**MINUTES  
CITY OF LAKEWOOD  
BOARD OF BUILDING STANDARDS/  
ARCHITECTURAL BOARD OF REVIEW/SIGN REVIEW  
FEBRUARY 13, 2020 at 5:30 P.M.  
LAKEWOOD CITY HALL  
AUDITORIUM**

**ARCHITECTURAL BOARD OF REVIEW**

**16000 and 15801 Detroit Avenue  
Market Rate Apartments**

Docket No. 02-08-20 (12558 Clifton)  
Front Porch/Deck - ABR - February 2020

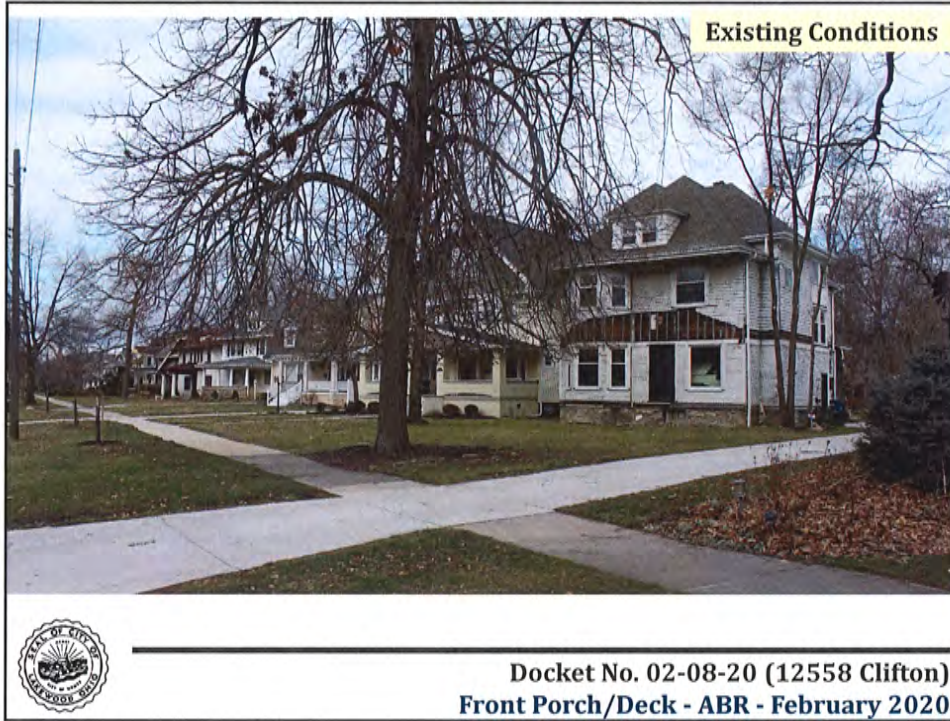
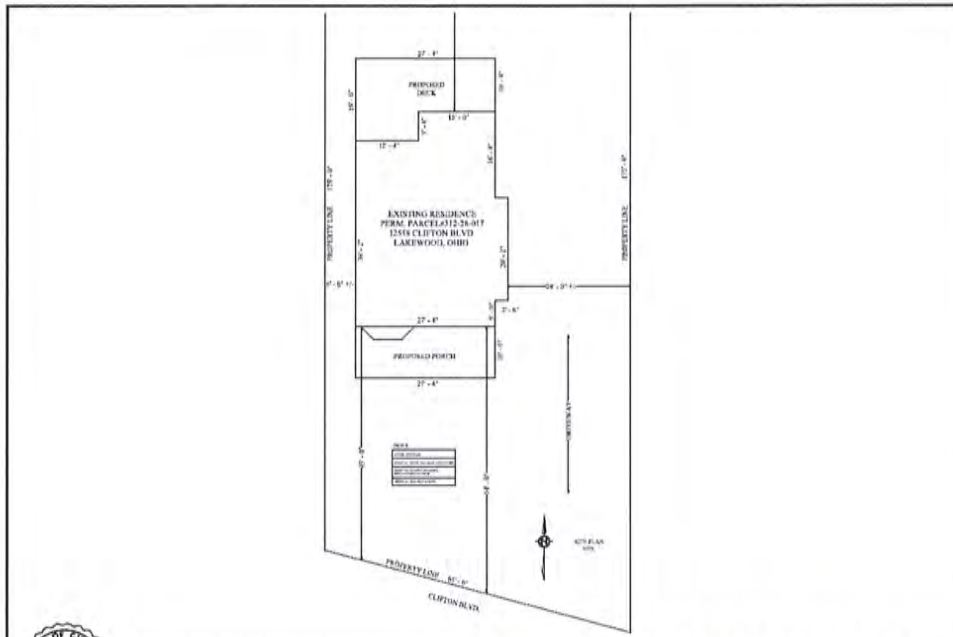
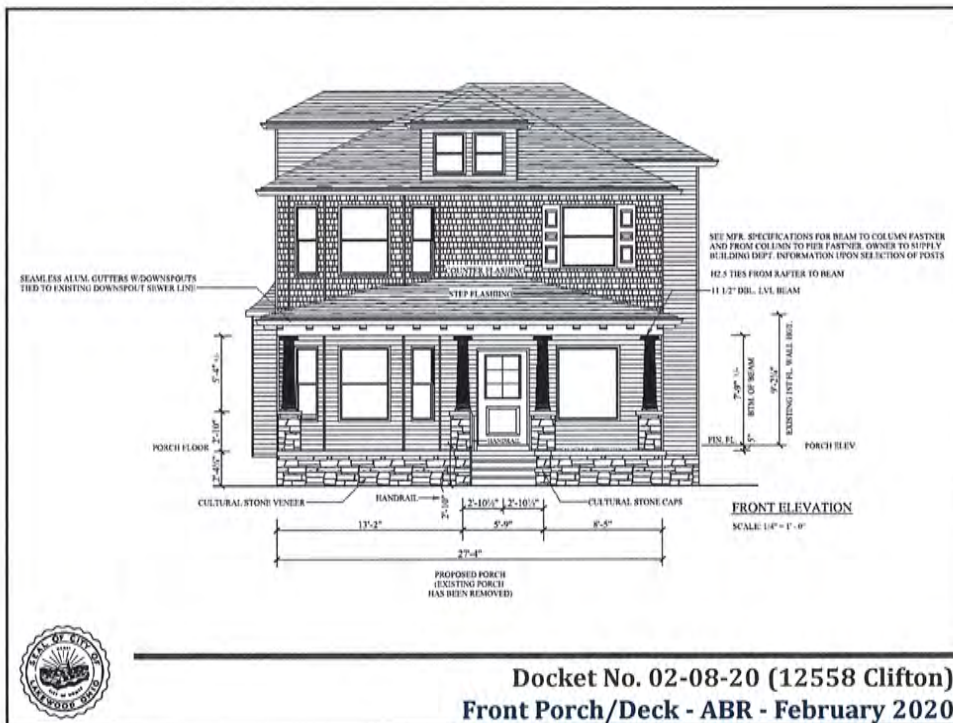
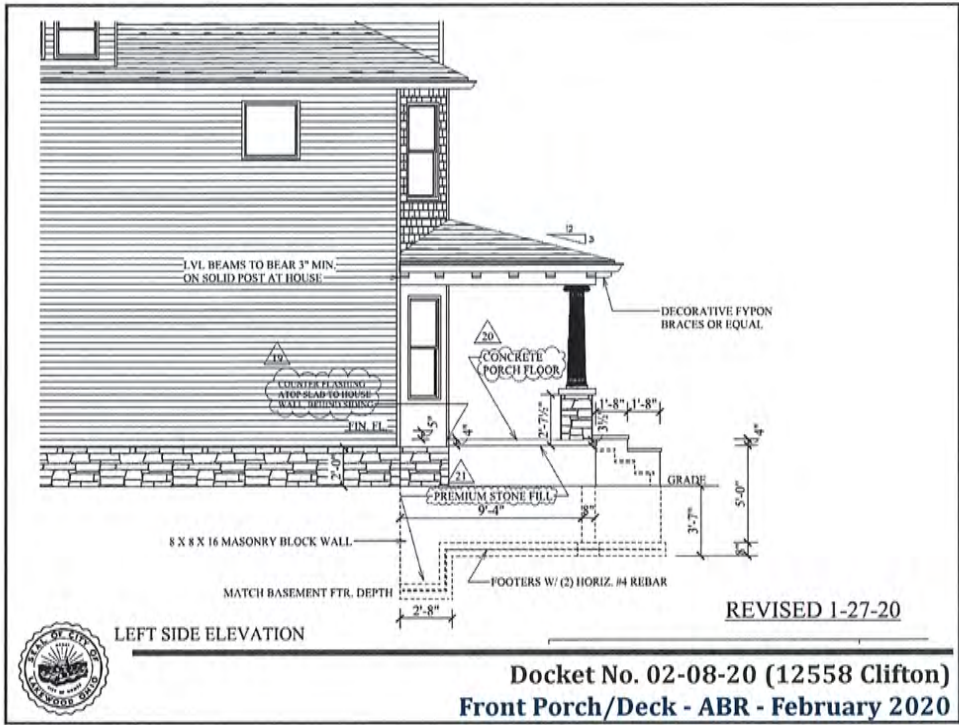
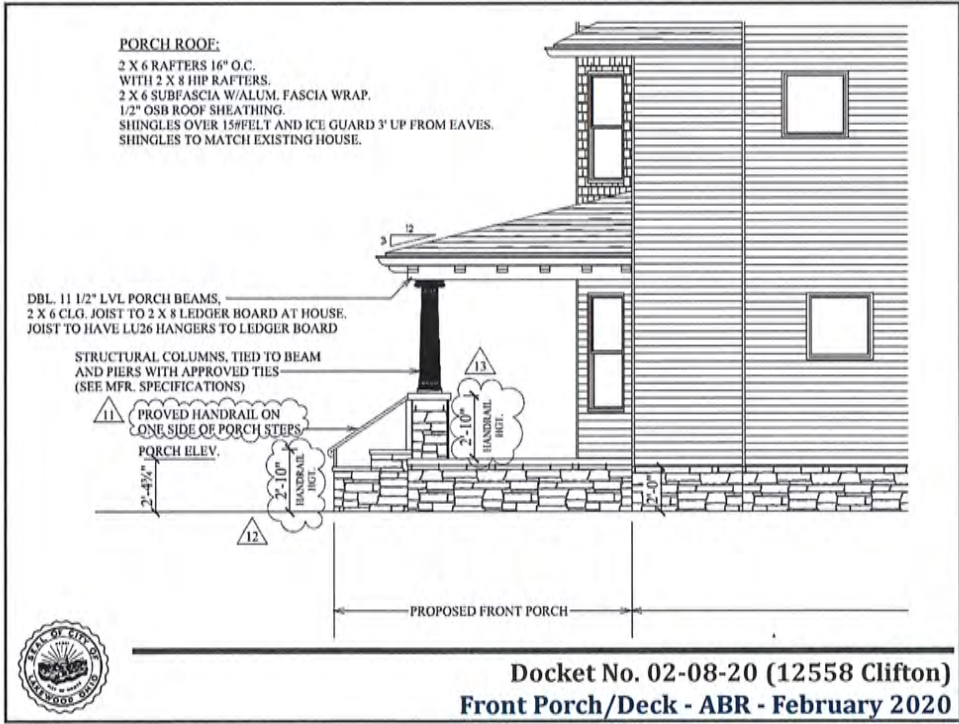
- Docket 02-08-20 (12558 Clifton). Administrative staff presented the submitted plans for this addition of a front porch/deck. Board requested more information/examples of intended materials (stone veneer, columns, roofing as indicated by plans) – and requested the applicant consider alternative materials that more closely aligned with existing front porch guidelines.

**Docket No. 02-08-20 (1310 Gladys)**  
**Front Porch - ABR - February 2020**

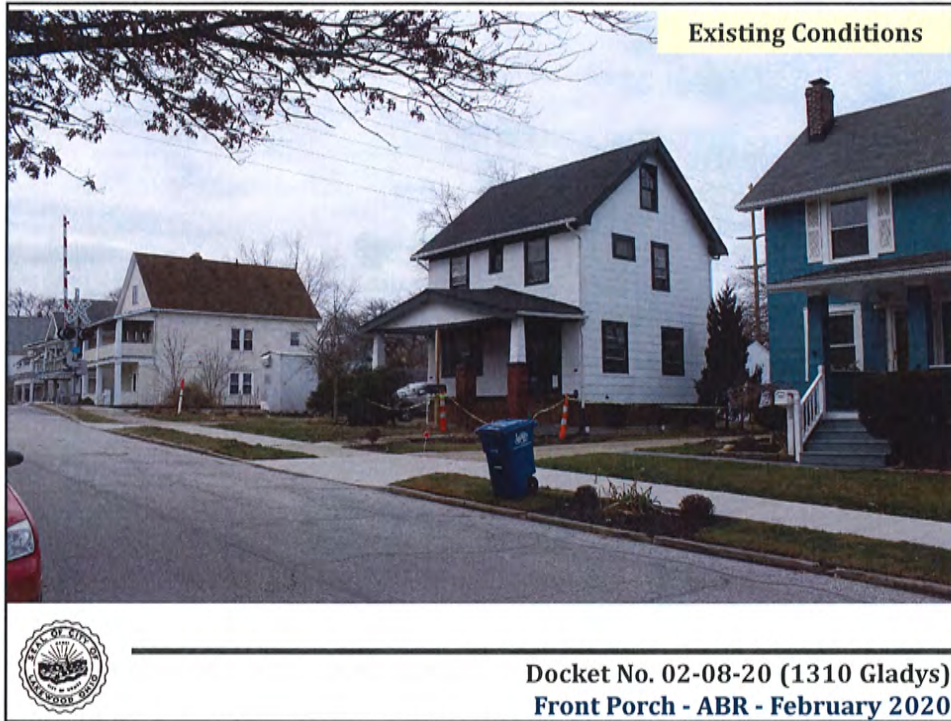
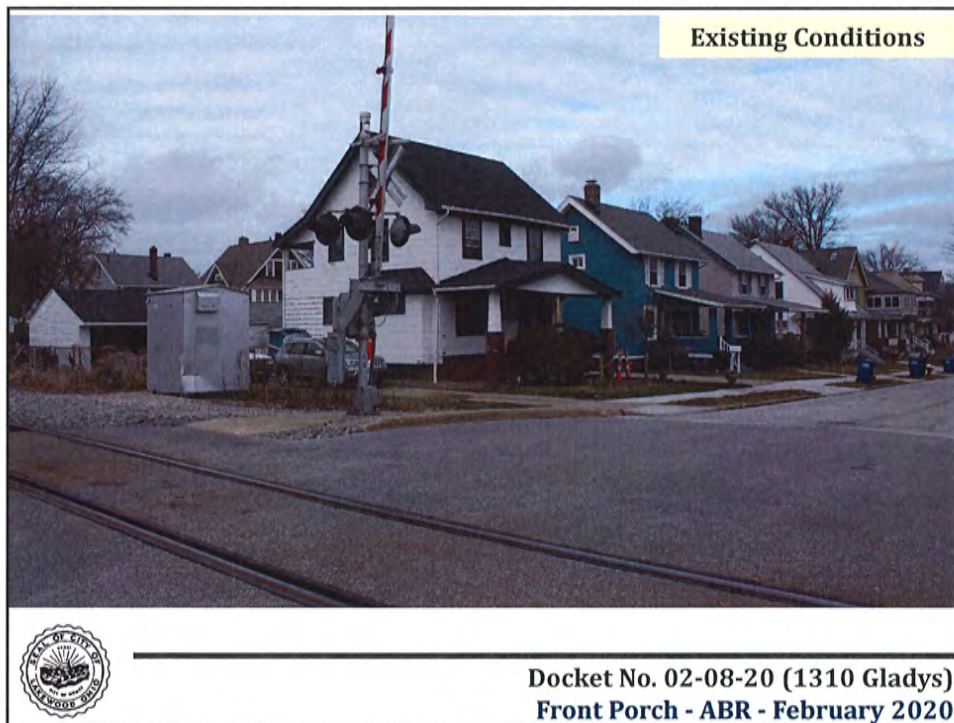
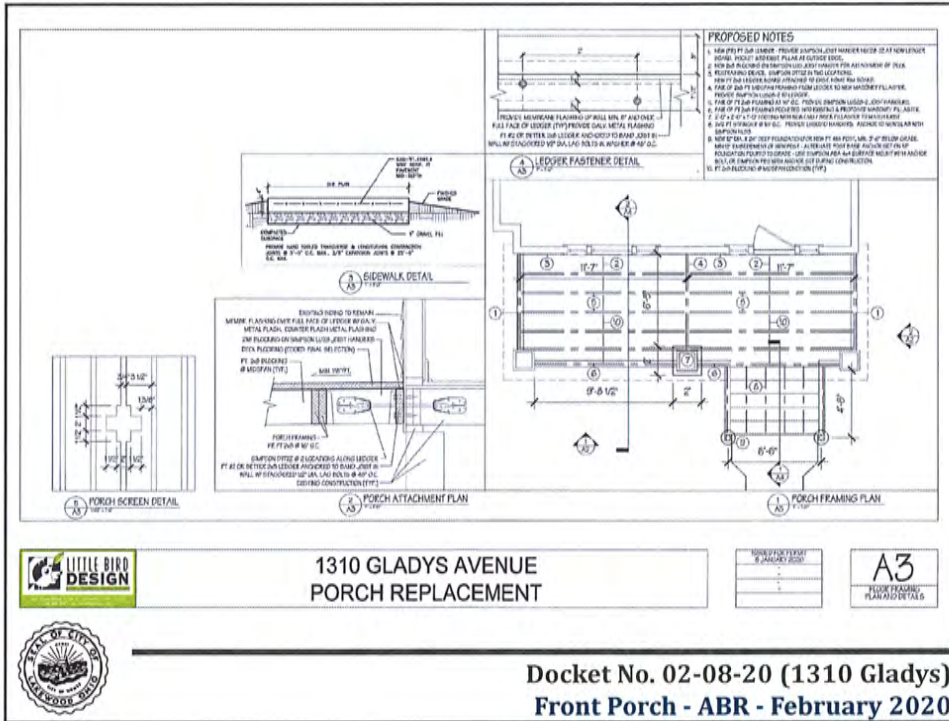
Applicant was present to explain the proposal. Staff overview of prior and current conditions. Board was supportive except for the proposed solid porch railing and handrail design, preferring that a decorative railing be installed for both that is more consistent with existing City front porch guidelines. Staff recommended that an update to the design that included decorative railing consistent with the guidelines could be approved administratively. Public comment was closed as no one addressed the issue.

- Docket 02-12-20 (1310 Gladys). Administrative staff presented the submitted plans for this rebuild of a front porch. Board requested the applicant consider alternative railing (decorative) design that more closely aligned with existing front porch guidelines.

- Porch railing and handrail design is updated to comply with existing porch guidelines (decorative railing), submitted for administrative review/approval.

DETAIL OF NORTH BUILDING ALONG  
BROCKLEY AVE

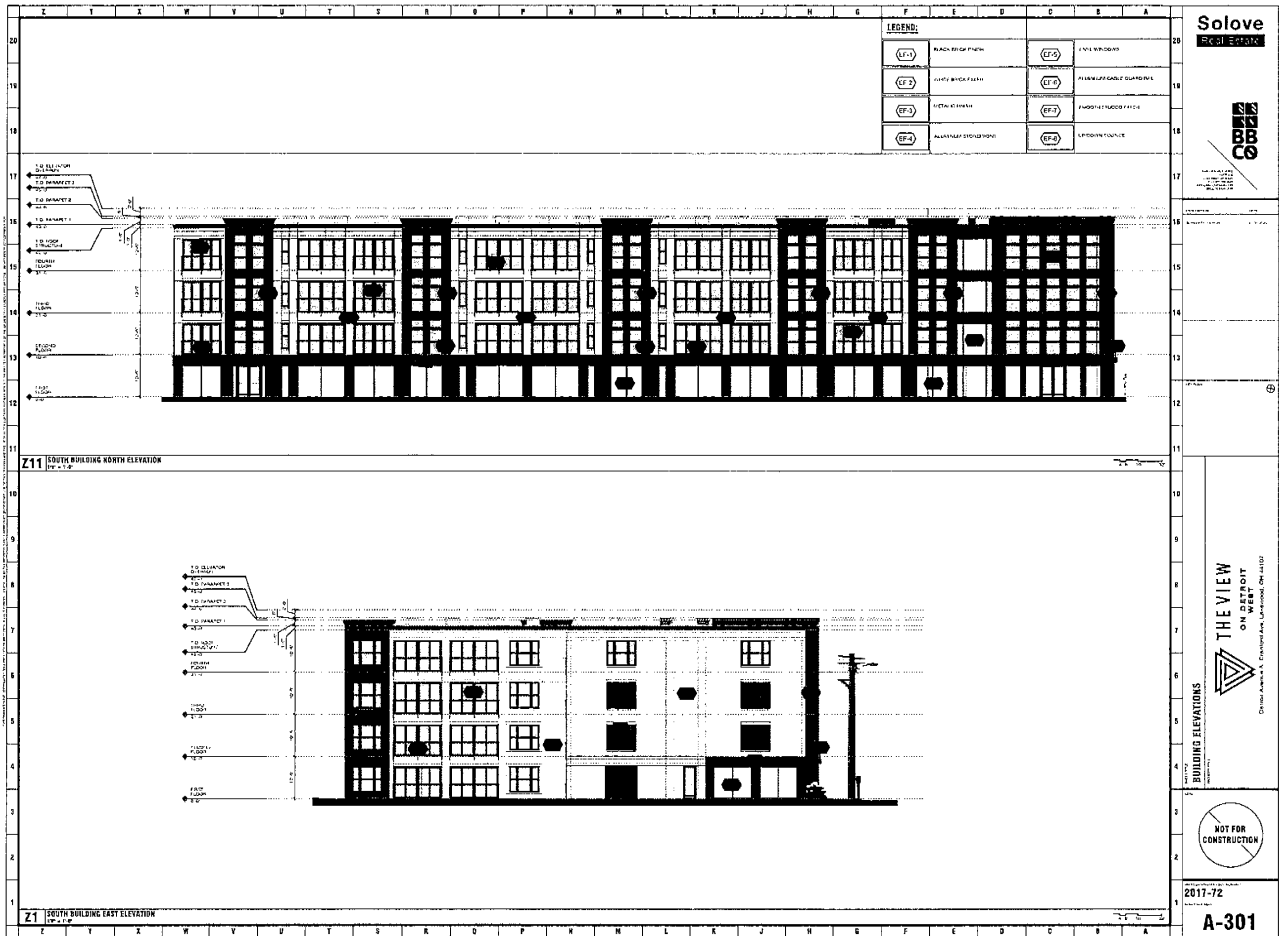
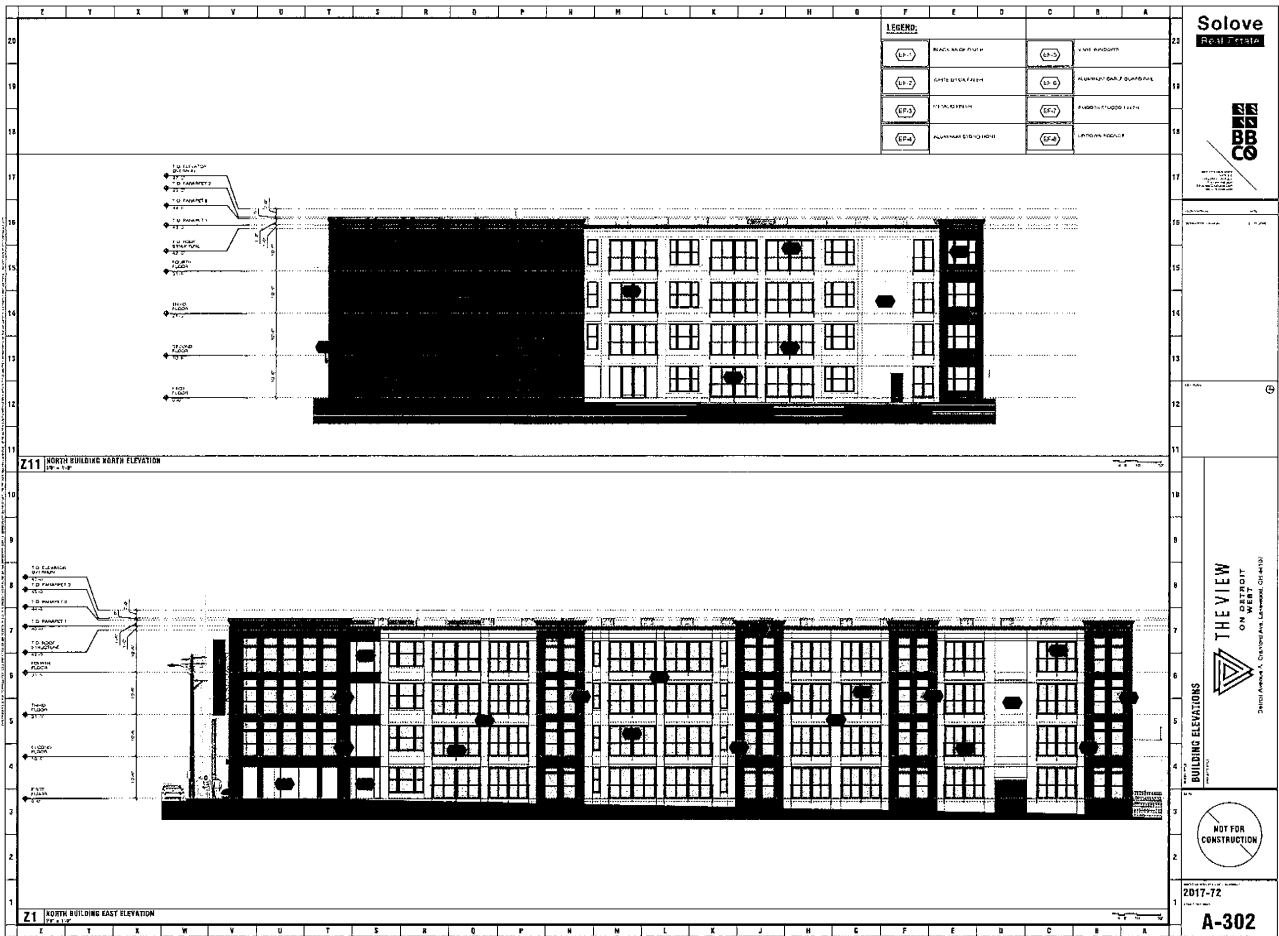
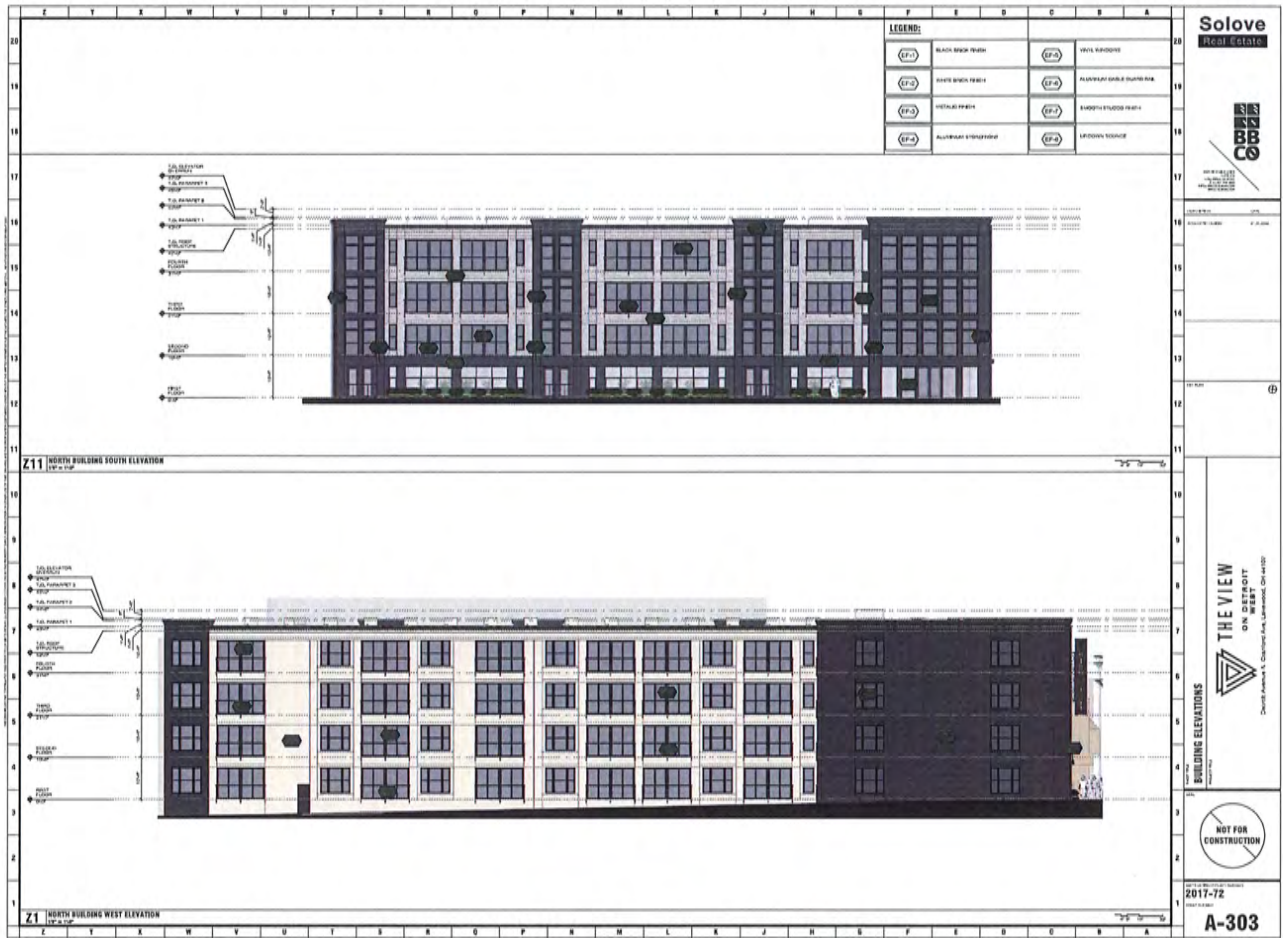
- Differentiation/dimensions of first floor versus upper floors – to work toward consistency with typical local mixed-use façade dimensions where first floor is differentiated by height/design elements from upper floors.

- First-floor (residential) integration with the streetscape (Detroit/Brockley) – to reconsider the Juliet balconies in terms of better (integration/functionality with sidewalk/landscaping)

- Consider carrying the brick pavers at lobby/entryways around the building edges
- Consider making the commercial/retail space entrance more distinct from the residential entries with different landscaping as to not obstruct the storefront windows.

- Look at the consistency of material use & appearance across all four sides (four-sided design)
- Consider shifting trash collection locations to lessen the potential conflict with residential street traffic.

- Request more detailed elevations and context/integration with Residential neighborhood streets.
